Alton Coal Development, LLC

Subject: Evaluation of Pipeline from Pit 10 to Sediment Pond 3, Pond 1 and facility waterline revisions, Alton Coal Development, LLC, Coal Hollow Mine, Kane County, Utah, C/025/0005, Task 4894

Title: Evaluation of Pipeline From Pit 10 to Sediment Pond 3 and Pond 1 / Facility update

**EVALUATION OF PIPELINE
FROM
PIT 10 TO SEDIMENT POND 3**

DRAWING: 5-8C

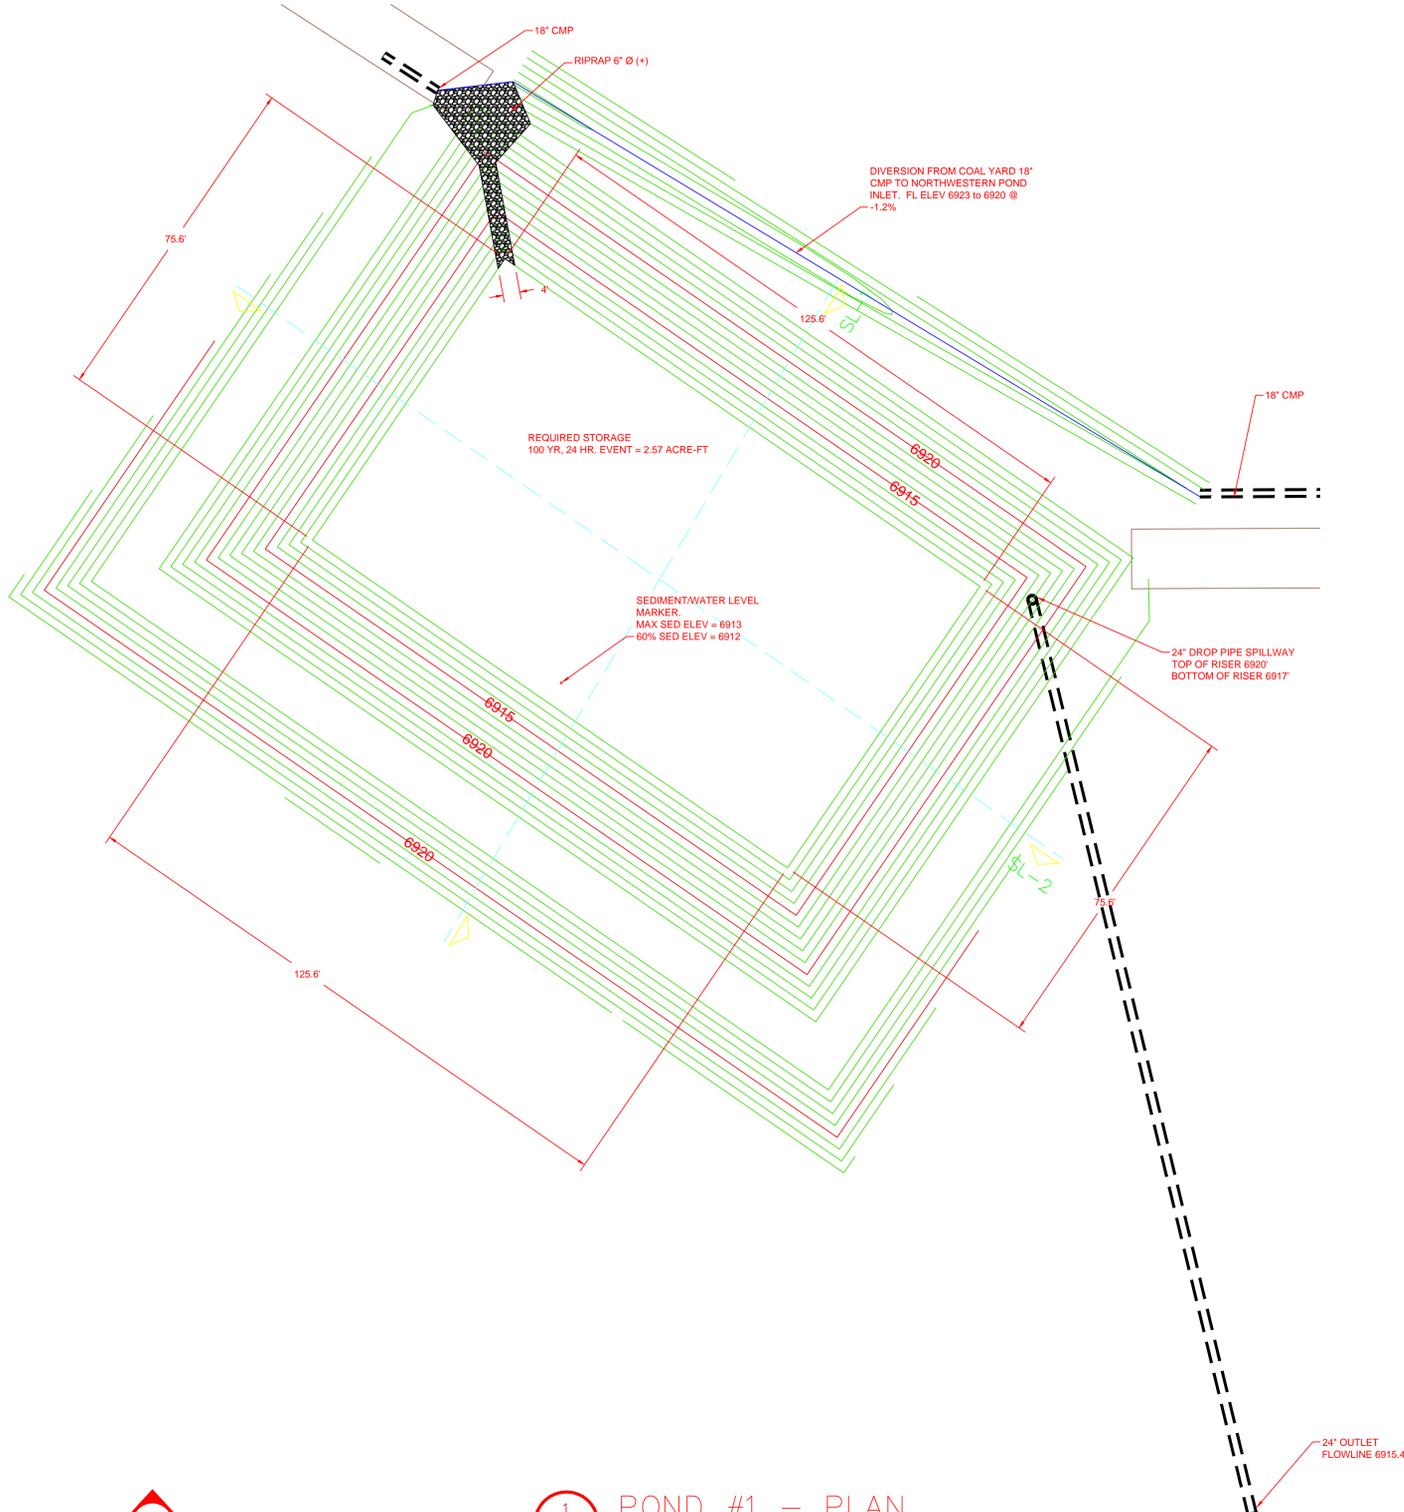
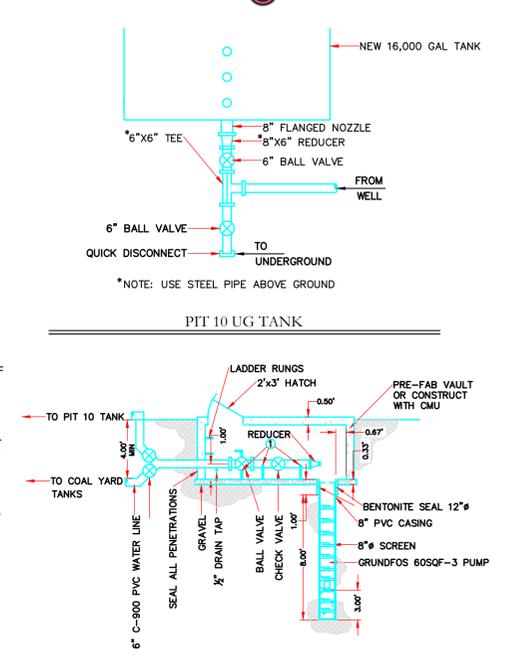
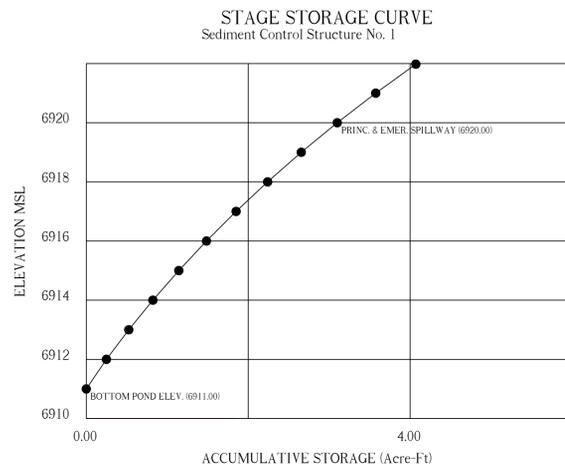
- There is no discussion of the tanks pads that should be included as it is relevant to bond estimates at final reclamation. The Permittee should detail how each of the respective tanks is secured, i.e concrete pads either within Chapter 5 or on Drawing 5-8c. If tanks are mounted on mobile equipment it needs to be clarified as such within the text.

R645-301-521.161 and -301-121.200 requires maps of the proposed features that clearly show buildings, utility corridors, and facilities to be used. The current drawing 5-8C does not meet

the minimum requirements of the above rule as the drawing is not clear and concise and missing information:

- A call out of concrete pads or other means of stabilization/foundations for tanks

The permittee will supply a corrected Drawing 5-8C that details the dimensions of the foundations for the respective tanks or add text to Chapter 5 including such details, clarify where the South and North Tank are located, and call out the number of tanks present at the facilities area.

Section 526 of the MRP has been updated to reflect the current configuration of tanks and associated pipelines, also Drawings 5-3, 5-8c with the design of the portable water tanks utilized at the mine.

Drawing 5-8C has been amended to show actual location of each tank, an accurate drawing of the tanks is included. The portable tanks have no concrete pads or footings as depicted. The texts for section 526 has been updated with descriptions of the tanks and there locations.

SEDIMENT IMPOUNDMENT POND 1 DETAILS
COAL HOLLOW PROJECT
ALTON, UTAH
DRAWING: 5-28

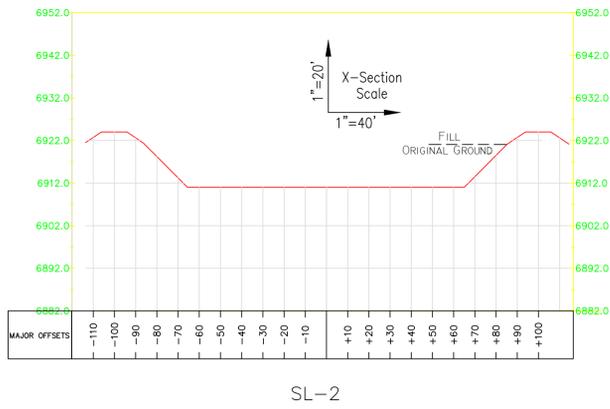
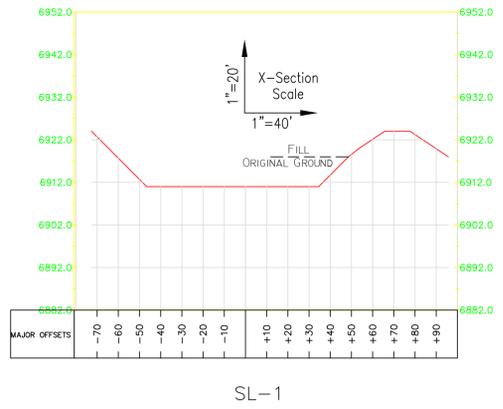
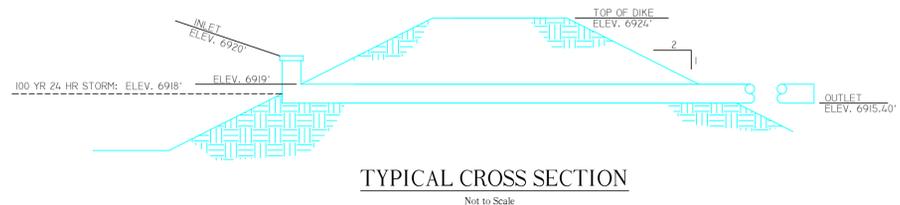
R645-301-121.200. Clear and concise. The Drawing 5-28 is of Sediment Impoundment Pond 1. The narrative in the center of the document should only refer to design specifications regarding Sediment Impoundment Pond 1. Remove any narrative that is not directly related to Sediment Impoundment Pond 1.

R645-301-531, -532, -533 & -742.220 requires certified detailed design plans for siltation structures and impoundments that meet 10 yr, 24 hr design storm. The updated Pond 1 has different dimensions from the original Pond 1 but the storage volume computations remain unchanged. The storage volume computations need to be updated for the as-built Pond 1.

Drawing 5-28 has been revised to remove the extra text, specifications for the ponds can be found within the MRP.

Computations for Pond 1 have been modified for the as-built Pond 1.
